**ALERT SERVICE BULLETIN**  
**Bell Helicopter** **TEXTRON**

NO. 407-07-79

**MODEL AFFECTED:** 407

**SUBJECT:** FREEWHEEL AFT SEAL P/N 209-340-265-103,  
INSTALLATION PROCEDURES IMPROVEMENT  
OF

**Figure 2. Installation procedures for seal 209-340-265-103**

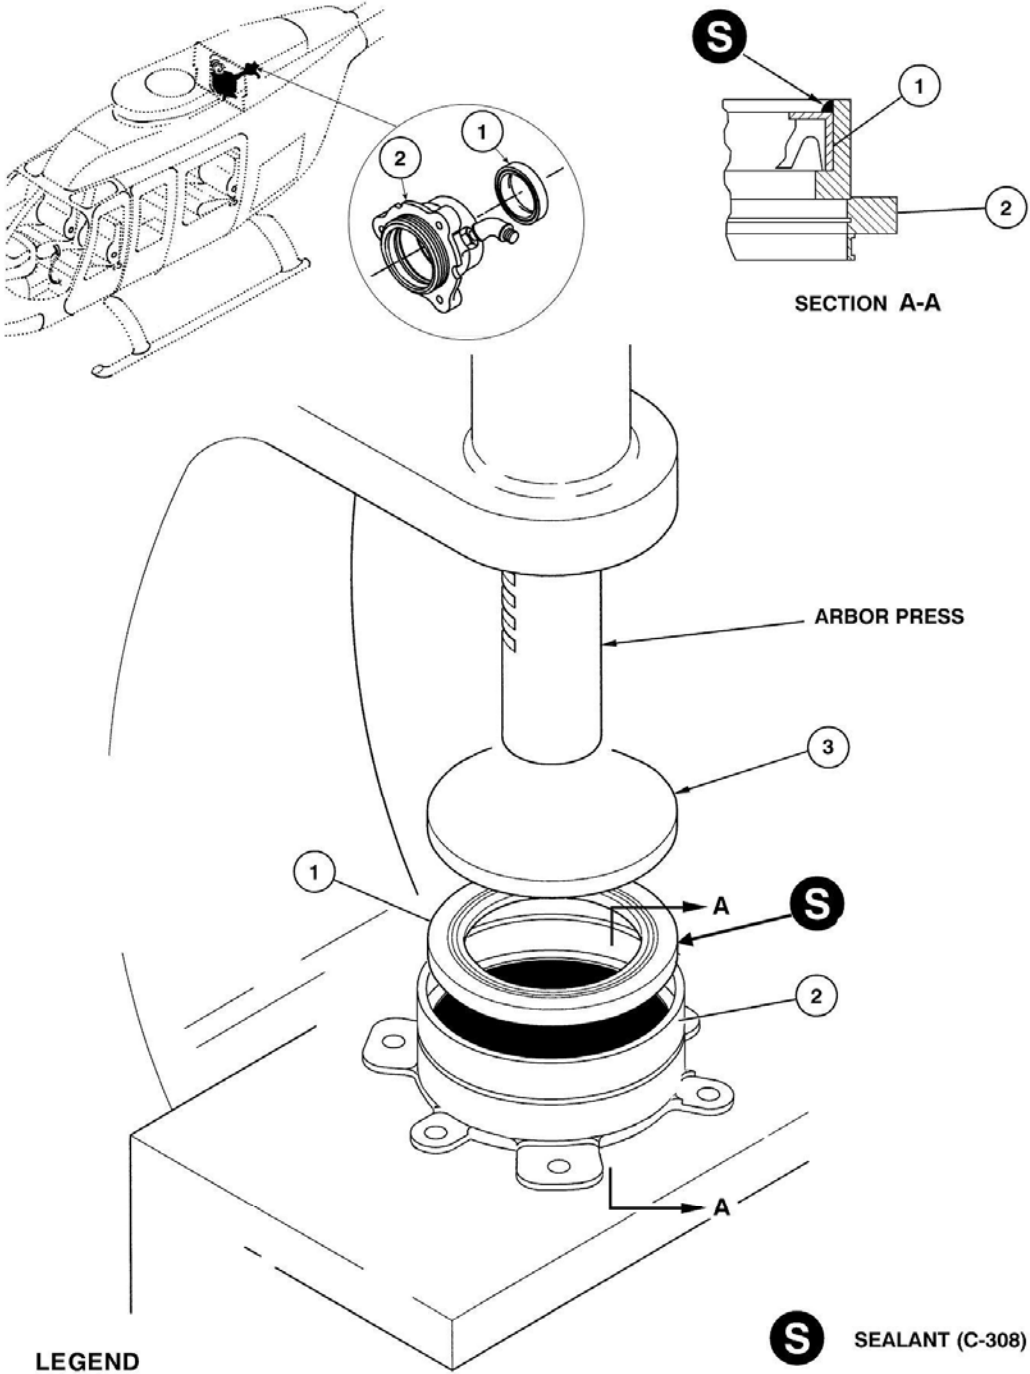
1. Remove the aft bearing cap (2, figure 2) (BHT-407-MM, Chapter 63).
2. Remove and discard the existing seal (1) (BHT-407-MM, Chapter 63).
3. Install the new seal as follows:
  - a. Clean the aft bearing cap (2) and the outside diameter of the seal (1) with solvent (C-316).
  - b. Apply sealant (C-308) to the outer diameter of the seal (1).

- c. While sealant is wet and using work aid (figure 2) push the seal (1) into the aft bearing cap (2) evenly and smoothly until seated.
- d. Fair the squeeze out of sealant (C-308) as shown in figure 2.
4. Complete the installation of the freewheel assembly (BHT-407-MM, Chapter 63) and allow time to cure the sealant (C-308) prior to ground run.
5. Perform a ground run for 5 minutes at 100% NR and inspect for leaks.
6. Make a log book entry to show that the PART II of this Alert Service Bulletin has been accomplished.

DO NOT USE A HYDRAULIC PRESS TO INSTALL THE SEAL. USE A MANUAL ARBOR PRESS TO CONTROL THE FORCE APPLIED ON THE SEAL FACE.
